CITROËN CARS CORPORATION

INDEX TO TRANSMISSIONS / DRIVESHAFTS

SERVICE BULLETIN #66

**DS 19 TRANSMISSION
SECOND GEAR AND REVERSE PATIOS**

Fig. 1

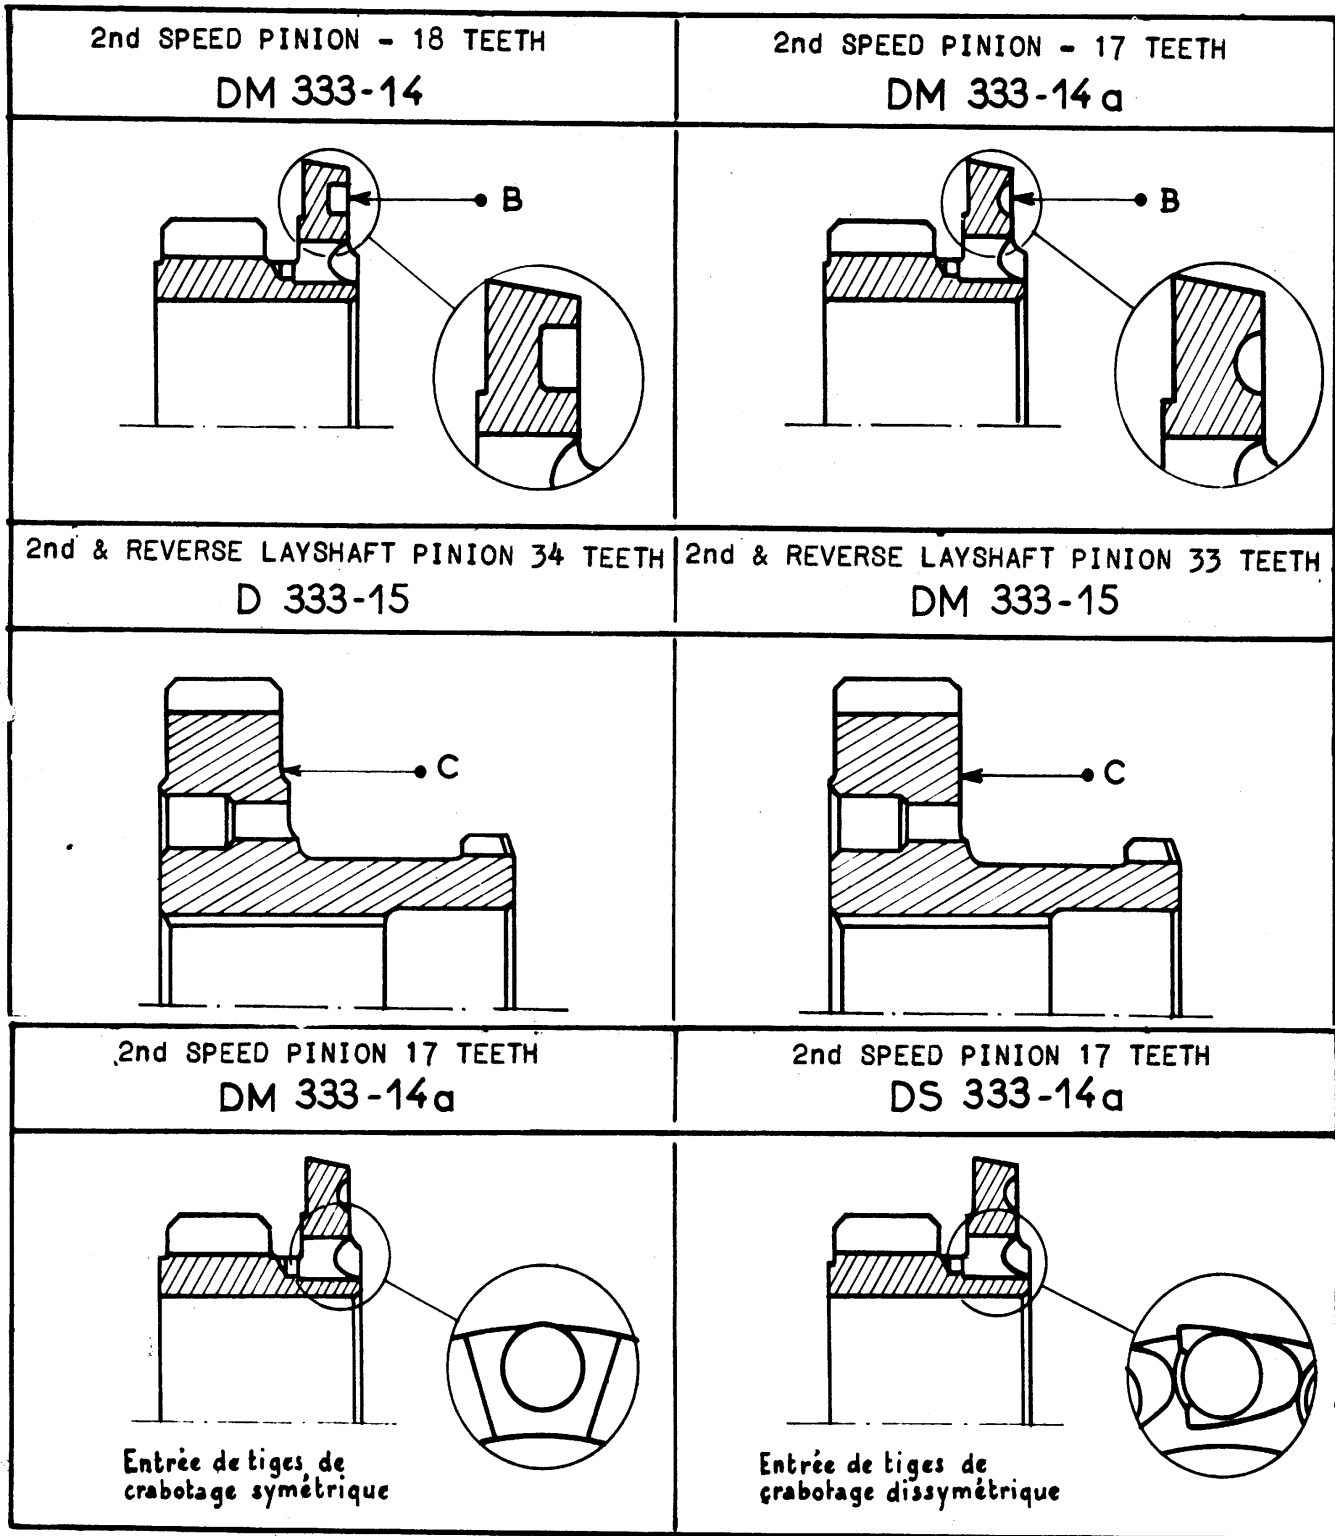
a) 2nd speed pinion (17 teeth). The difference between DM 333-14A and DS 333-14A is in the pilot openings (see figure 1).

Fig. 2 REVERSE GEAR

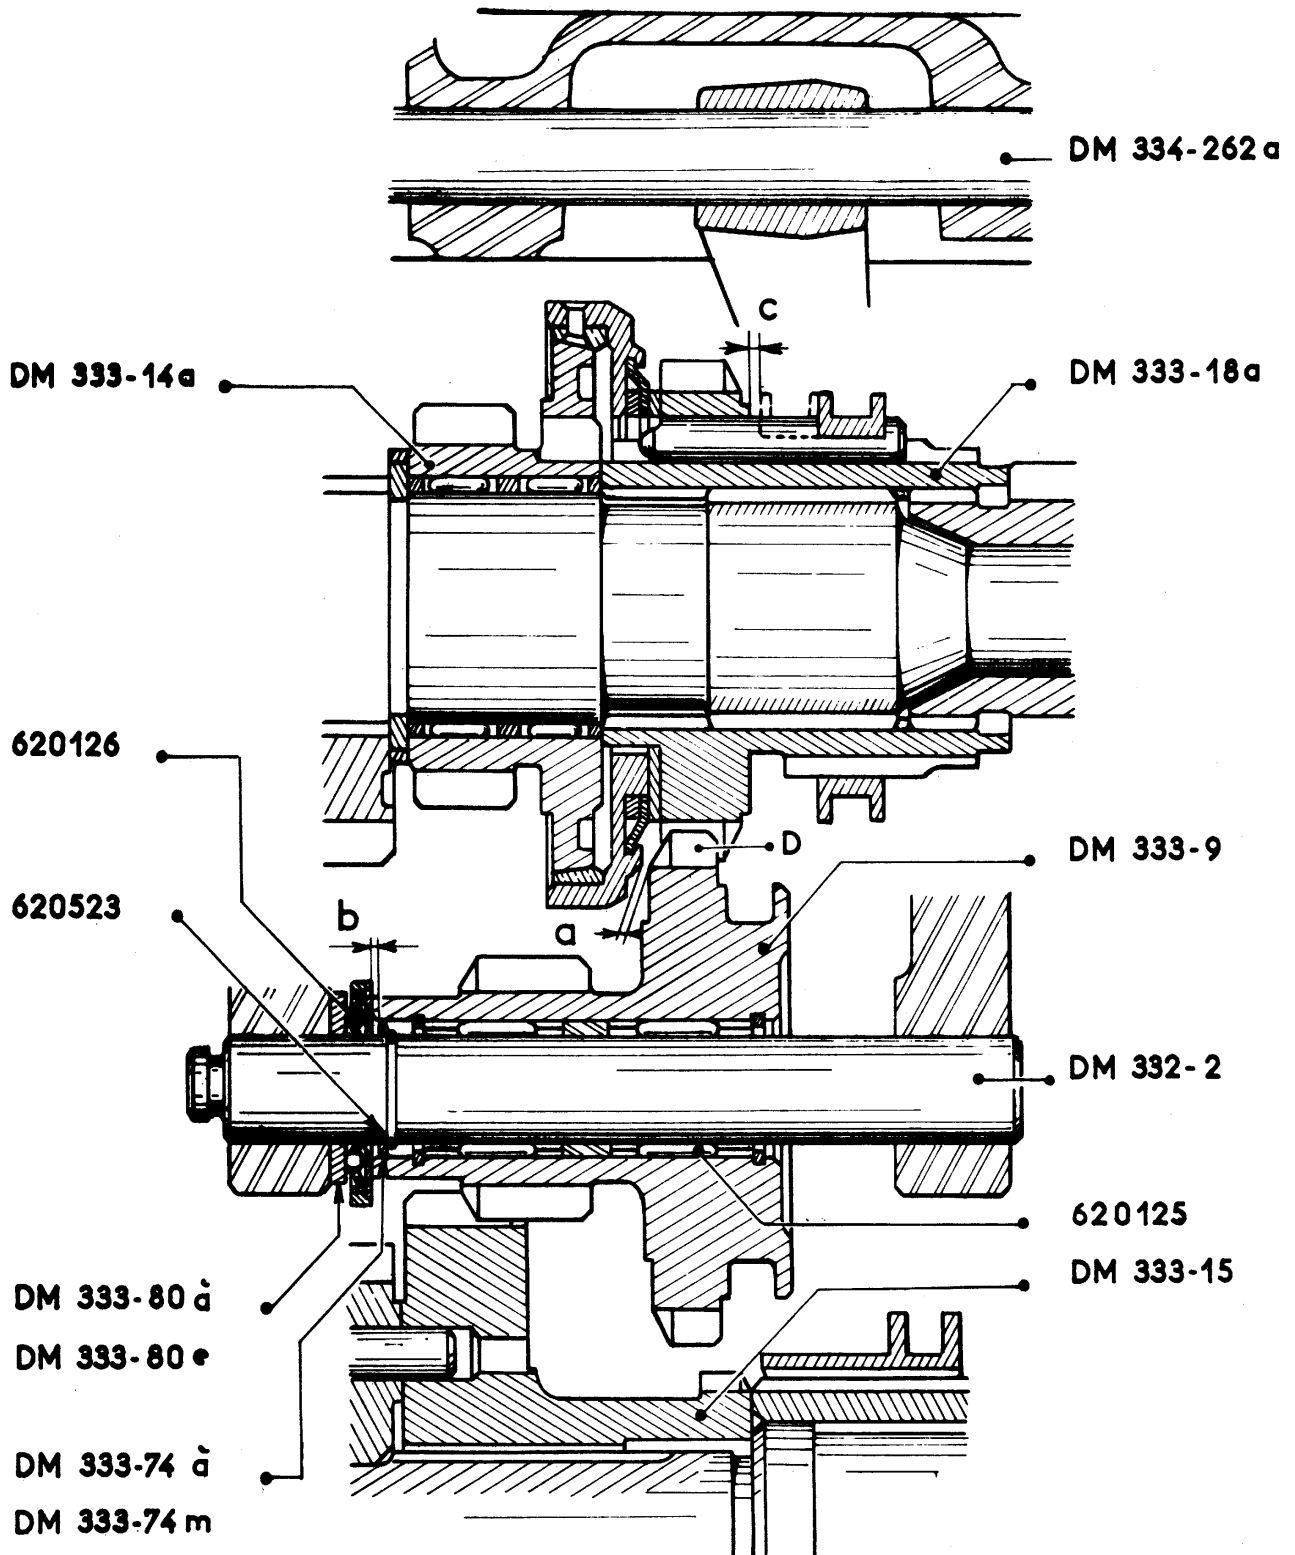
a) Clearances to be respected (see figure 2).

Clearance "a" 0.0118" to 0.0315" between 2nd speed synchro and tooth D of the sliding reverse assembly.

Clearance "b" 0.0039" to 0.0197" between the thrust washer and circlip.

Clearance "c" 0.0787" to 0.0197" between 2nd speed sliding collar and reverse gear.

SERVICE BULLETIN # 69
DS 19 GEAR BOX

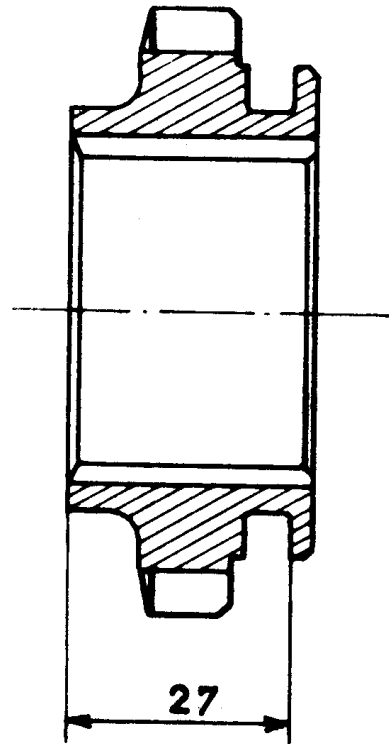
The DS 19 gear boxes are now equipped with a narrower sliding reverse pinion.

The former and new pinion have the same part Number: D 333-9 and are interchangeable.

PREVIOUS ASSEMBLY

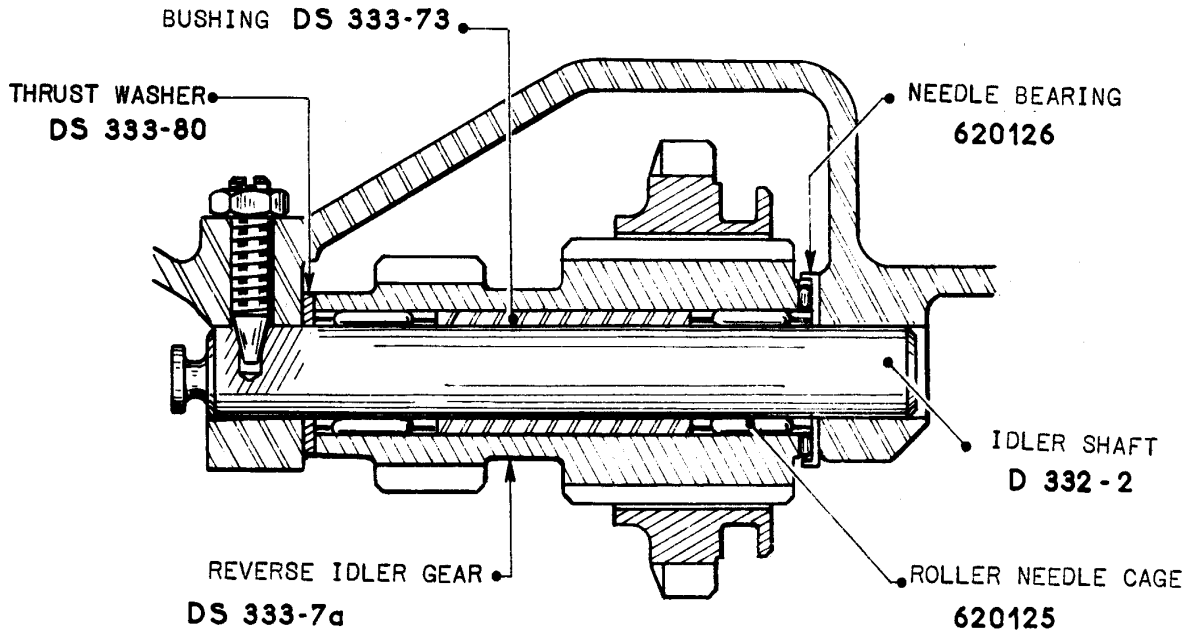
On DS 19 Model, the assembly of the reverse idler gear (10 teeth) has been modified as follows

- 1) Both ends roller bearings of the previous assembly are replaced by a needle bearing # 620126 and a thrust waeher # DS 333-80. Thus, the idling gear, the distance sleeve and the roller needle cages are also modified.
- 2) A conical seat on the idler shaft enables the removal of the latter, rendering the previous end threaded hole unnecessary (see sketches).

IMPORTANT: The adjustment of the end play is no longer required. The play is pre-set according to the tolerance of the components and must be mounted with coppered side facing the idler gear.

REVERSE IDLER TRAIN

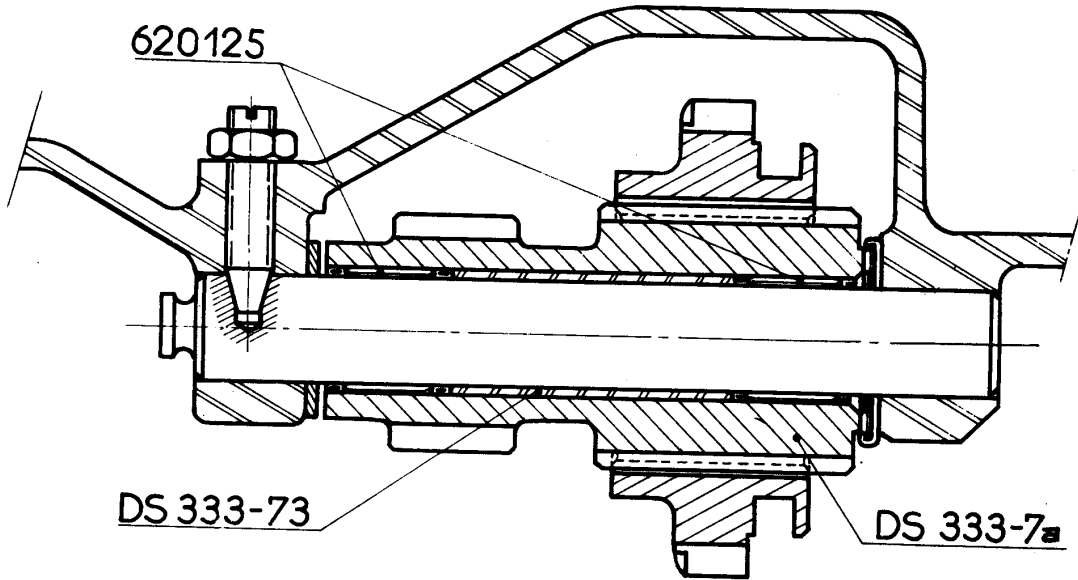
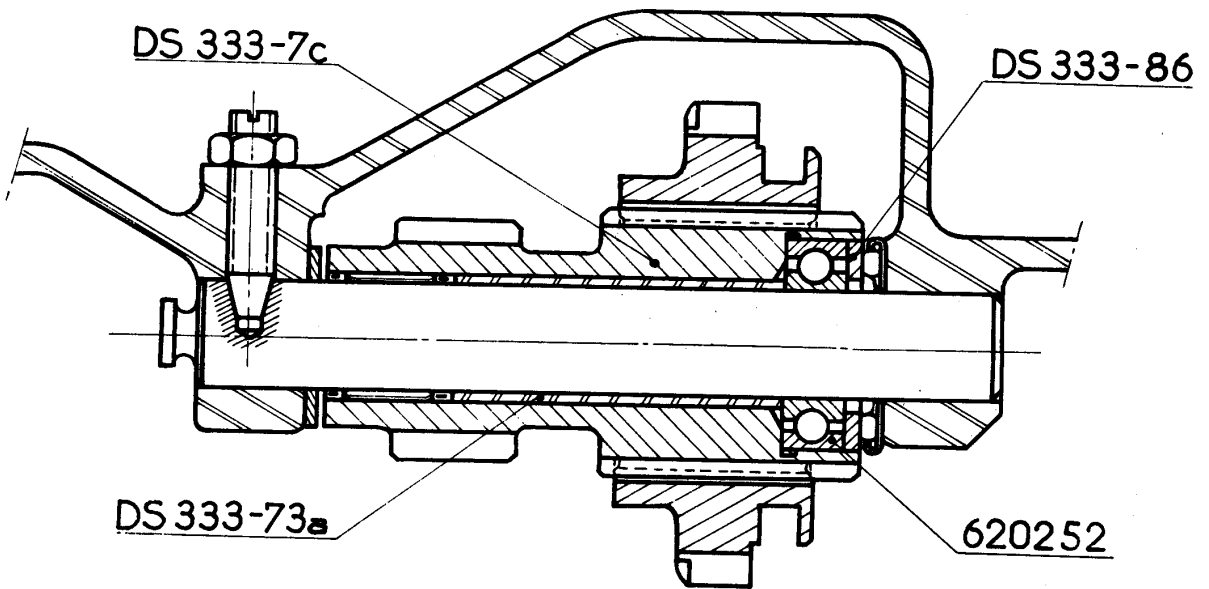
The reverse idler train has been modified.

The needle bearing 620125 next to the thrust bearing has been replaced by a roller bearing (See sketches).

It is possible to install the new idler train on the old type gear box providing that above listed parts are replaced.

DS 333-040
Reverse train assembly complete

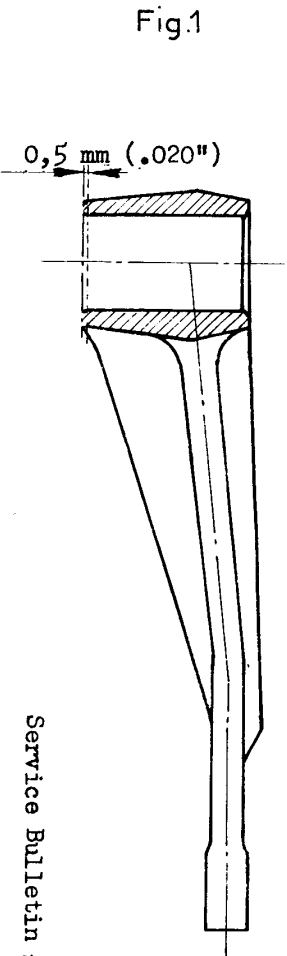
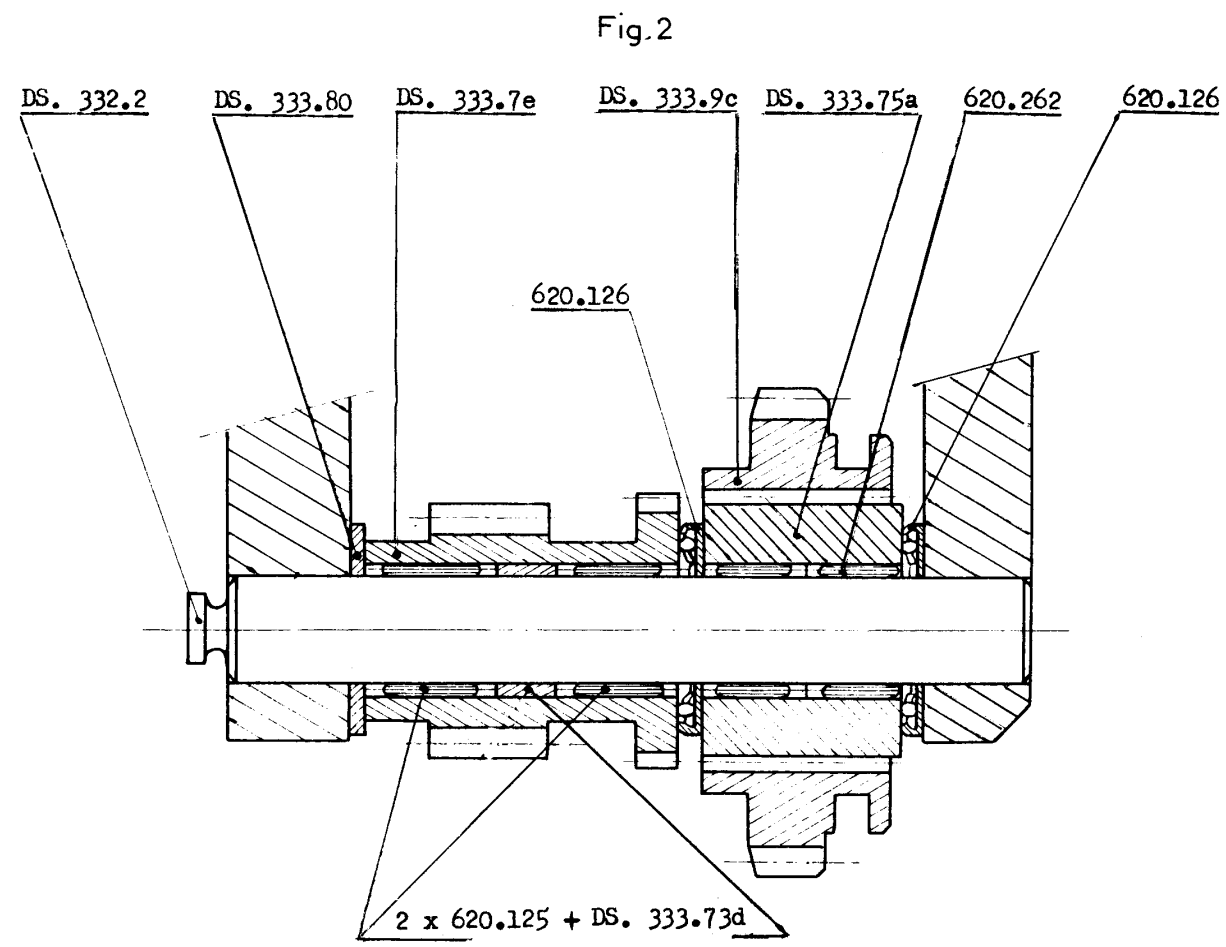
b) Position parts as shown in fig. 2.

c) In order to insure a correct engagement of the reverse gear remove 0.5 (.020") material from the reverse fork hub as shown in fig. 1.

b) Position the reverse gear train assembly as shown in fig. 2.

MODIFIED REVERSE IDLE GEAR

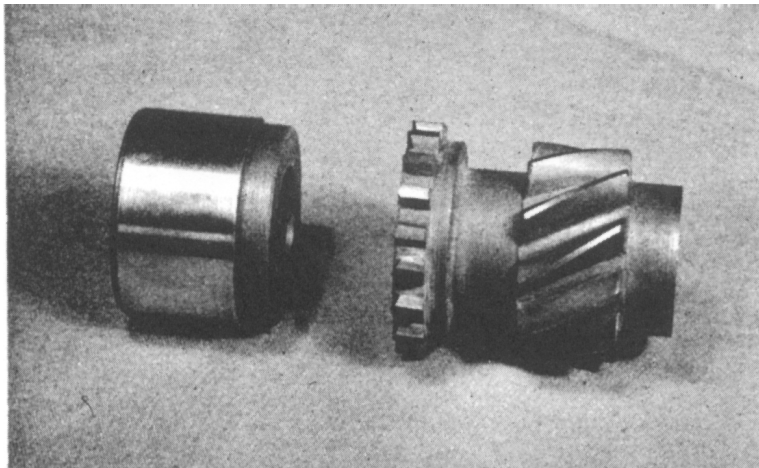
The sleeve D 333-75A is modified. It has now a shoulder as shown in figure below.

The new sleeve is interchangeable with the previous one without any further modification. For the assembly, the shoulder on the sleeve must face the reverse idler gear D 333-7A, as shown below.
